As-Built Inspection Report

Desktop Trees & Shrubs Review

Dakota Access Pipeline

ND PSC Case No. PU-14-842

Appendix A – Maps

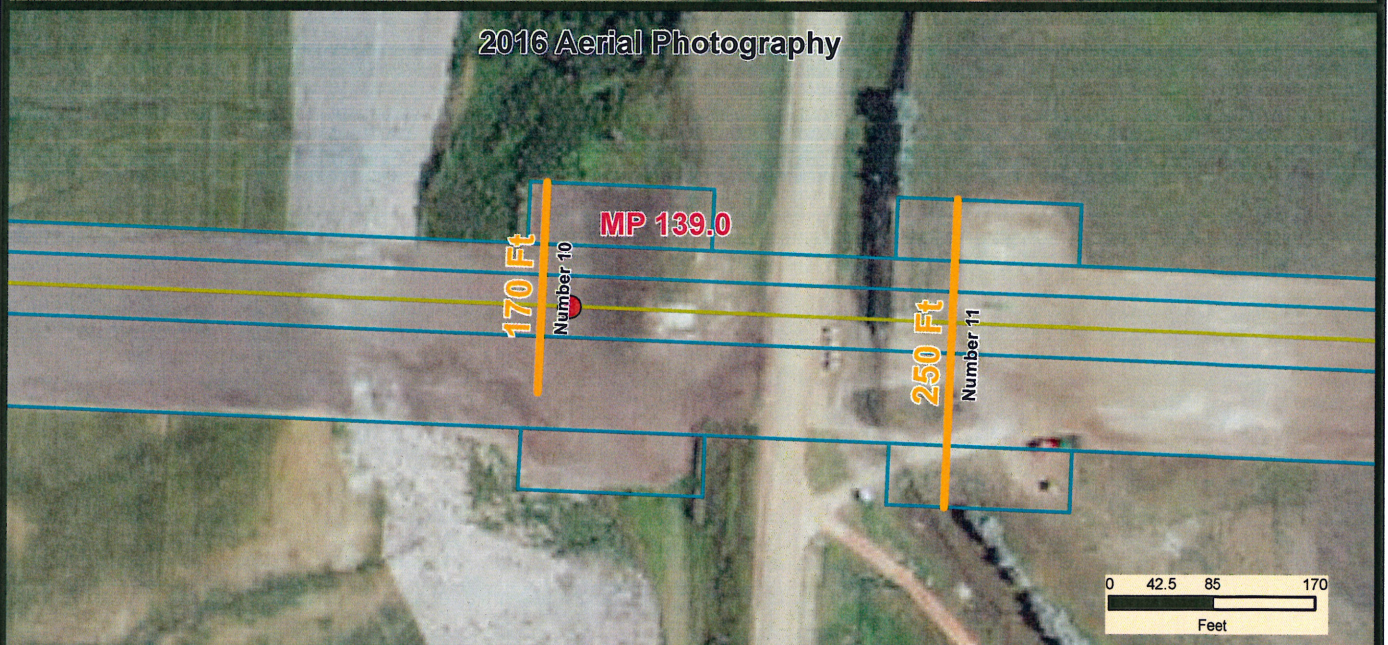
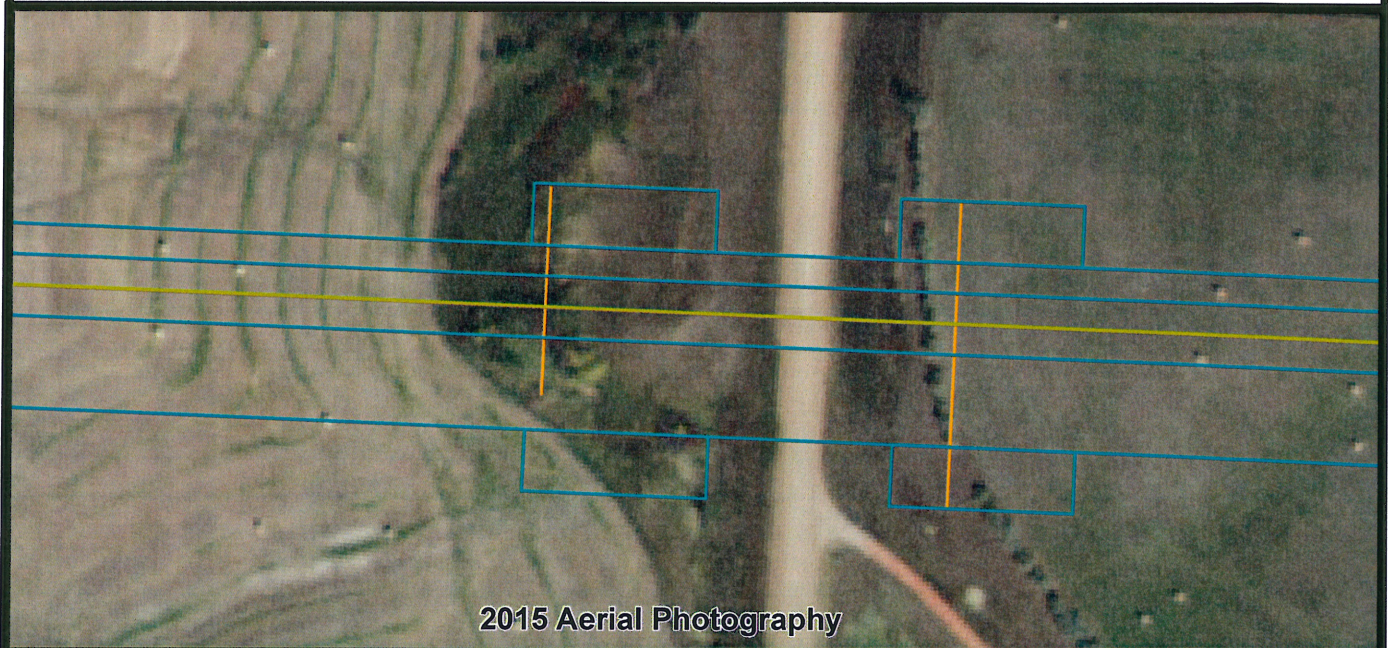
Appendix A contains examples of three of the 83 sites identified. These maps explain the methodology employed to use aerial photography for this study to determine potential violations.
